ADDENDUM NO. 1

Williamson County Schools

Cooling Tower Replacements at Fairview Middle, Heritage Middle and Franklin High

WCS RFB#1197 EEI#19-194

SHEET M3.1 - See revised Sheet dated 2/17/2020.

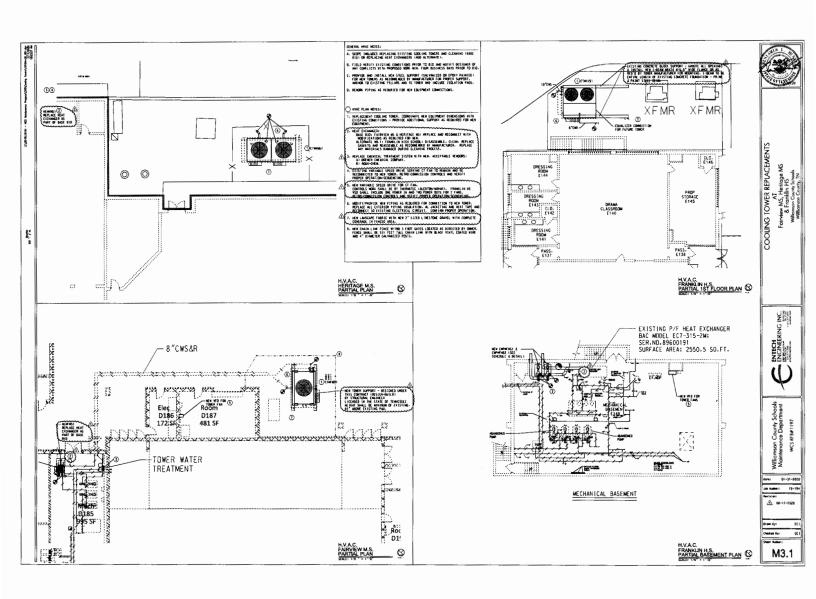
- 1. Change HVAC PLAN NOTE 2 to replace Fairview & Heritage heat exchangers as part of base-bid and clean Franklin High School heat exchanger as Alternate No. 1.
- 2. Change HVAC PLAN NOTE 3 to add Aqua-chem.
- 3. Change HVAC PLAN NOTE 5 regarding tower fan VFD control.
- 4. Change HVAC PLAN NOTE 7 as follows: NEW LANDSCAPE FABRIC WITH NEW 2" SIZED LIMESTONE GRAVEL WITH COMPLETE COVERAGE IN FENCED AREA.
- Reference HVAC FAIRVIEW MS PARTIAL PLAN: Change note regarding NEW TOWER SUPPORT to clarify "DESIGN BUILD".
- 6. Reference Franklin High School Tower I-Beam note: change to clarify flange width & weight.

SHEET E1.1 - See revised Sheet dated 2/17/2020.

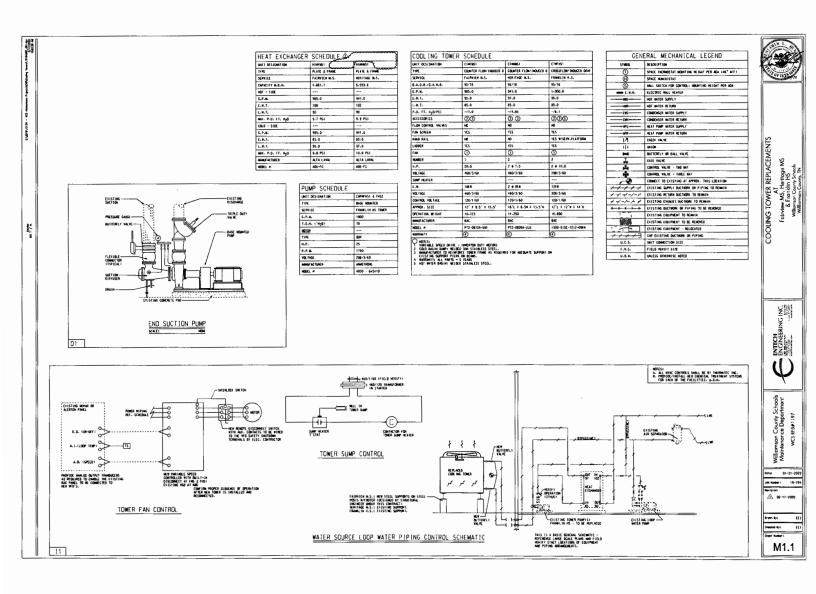
1. Change feeder from fan tower disconnect switches to VSD to 'D2' feeder for Franklin High School.
